Evaluation of the AoR Delineation Modeling Approach in Carbon TerraVault's Monterey Formation A1-A2 Class VI Permit Application

This area of review (AoR) delineation modeling evaluation report for the proposed Carbon TerraVault 1 LLC (CTV) Class VI geologic sequestration project summarizes EPA's review of the modeling performed by CTV as described in the Area of Review and Corrective Action Plan (AoR CA), which is Attachment B to CTV's August 2021 permit application and associated files submitted to the AoR and Corrective Action Module of the GSDT. This review also addresses modeling-relevant site characterization information in the permit application narrative and in the PISC and Site Closure Plan (Attachment E). Because the AoR modeling accounts for both of CTV's proposed injection wells (357-7R and 355-7R), this evaluation applies to both wells. [Clarifying questions for CTV and requests for supplemental information are provided in blue within the text below.](#)

Figure 4: Schematic section of the storage site with inputs to critical pressure calculation. Values for the USDW are based on the 326-7R well. The injection depth is based on the 357-7R injector. Using data from wells 357-7R injector and 326-7R the critical pressure is 3,400 PSI.

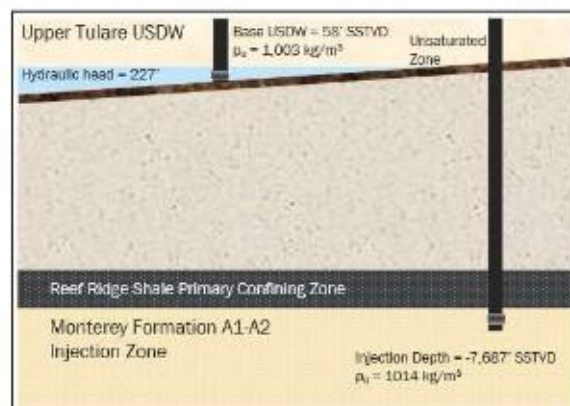
- *Please define the variables shown in the critical pressure calculation and their corresponding values shown in Figure 4 of the Critical—Pressure—Calculation PDF.*
- *The injection depth shown in Figure 4 of the Critical—Pressure—Calculation PDF (7,687 ft SSTVD) is different than the perforated depths shown in Table 5 of the AoR CA (7,728 ft MSL). Please confirm that this difference is due to ground level reference elevation. If not, please change the depth in Figure 4 and/or Table 5 to reflect the correct injection depth.*
- *If any of the 152 wells in the AoR penetrate the entire Reef Ridge Shale, please explain how they are accounted for in the geomodel.*
